ADDENDUM NUMBER THREE (3)

DATE: August 4, 2009

PROJECT: JOSEPH B. LANCASTER ELEMENTARY SCHOOL
ST. TAMMANY PARISH SCHOOL BOARD

1 FIN #2
Scale: 3/4" = 1'-0"

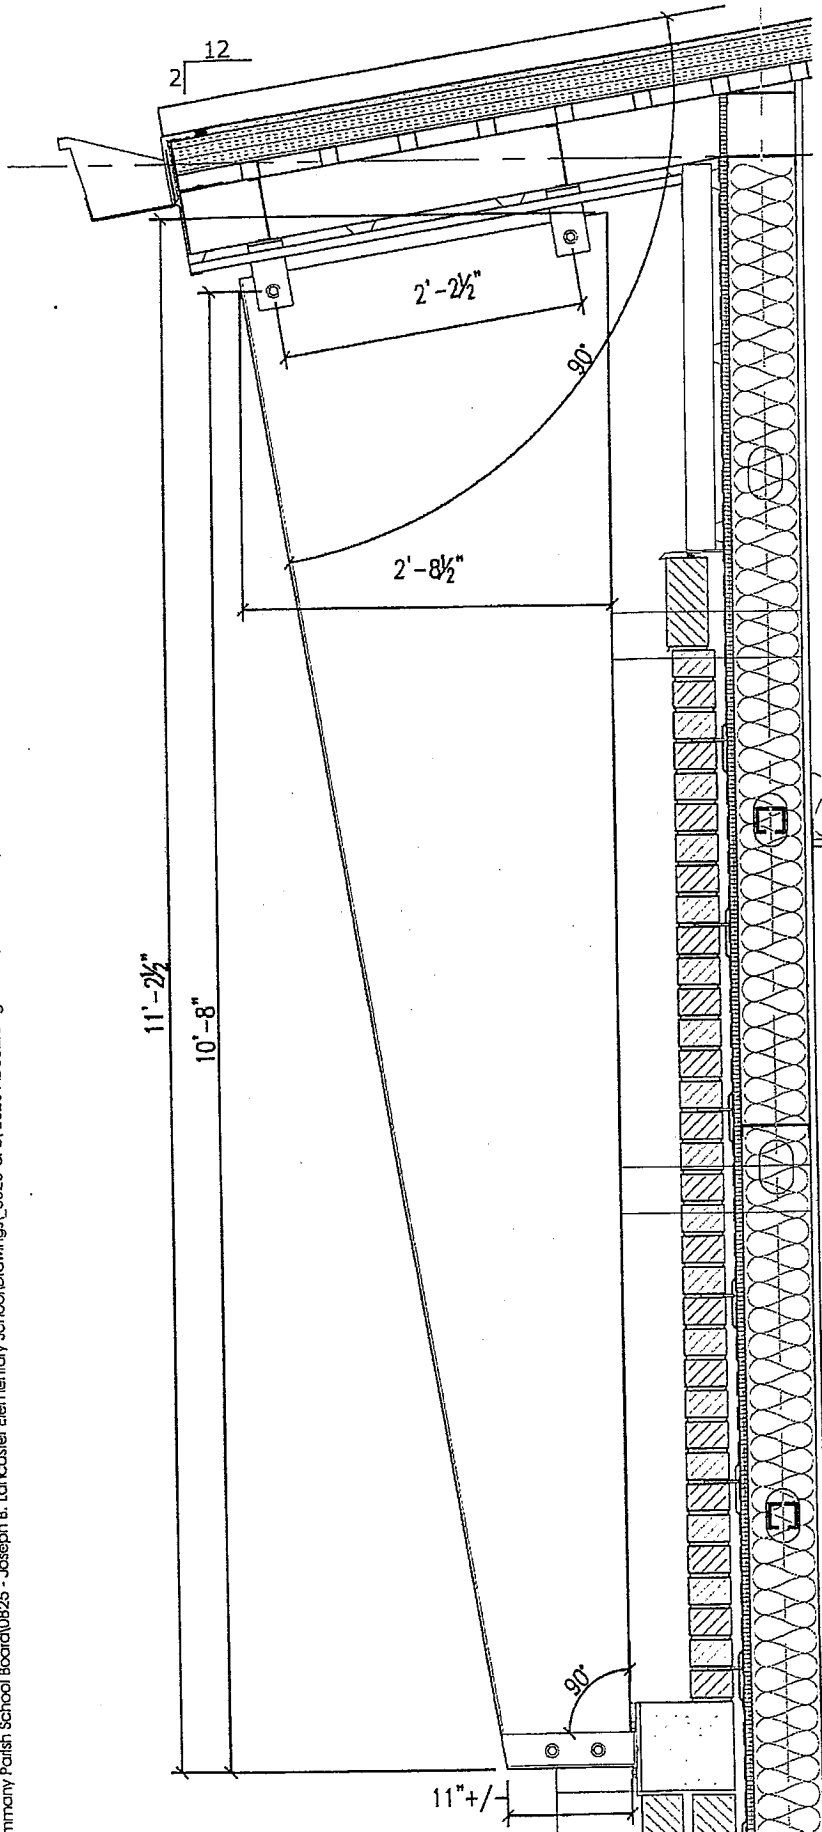
52. Refer to Detail 5/A315:
Delete Note "All top tracks to have 2" legs, typ." and replace with "Refer to Structural for all top track requirements".
53. Refer to Details 1 and 2/A318, Brackets (Fins):
See attached Drawings AD301 and AD302 for clarification of dimensions and materials.

1 FIRST FLOOR - PLUMBING (RE: P103)
SCALE: 1/8" = 1'-0"

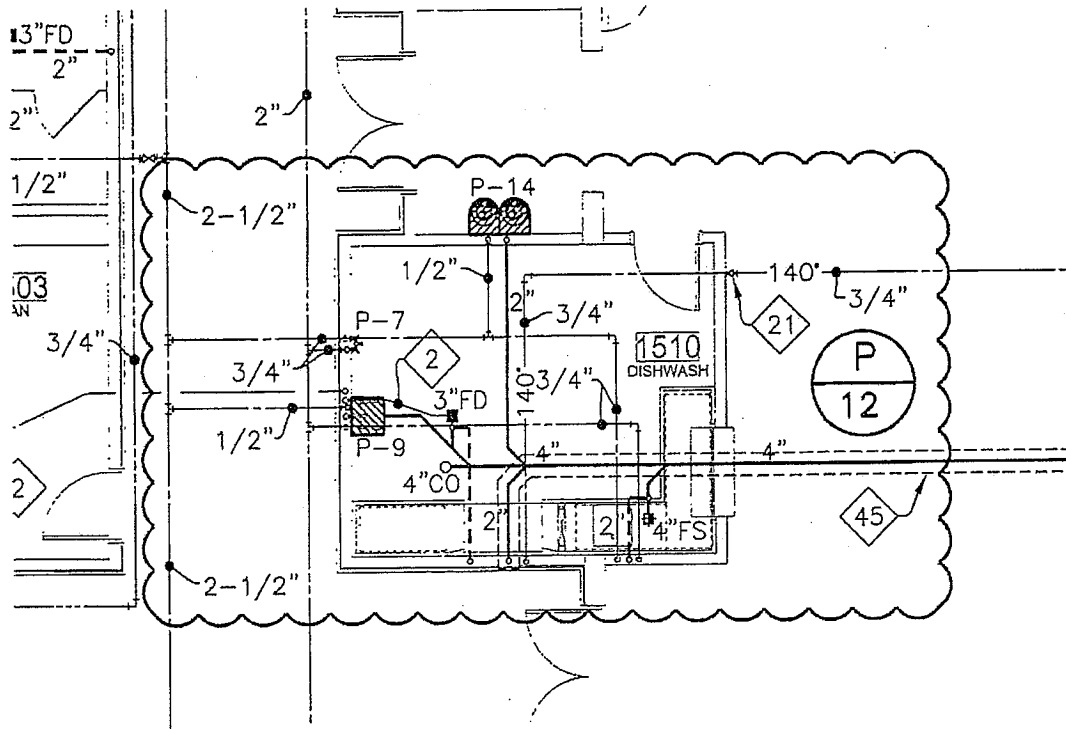
58. General Clarification:
Dishwasher Hood located in Dishwash Room #1510 to be 56x42. Size not previously noted on construction documents.
59. Refer to Sheets P103:
Refer to plumbing sketch PSK-07 for routing of domestic water in Room 1510.
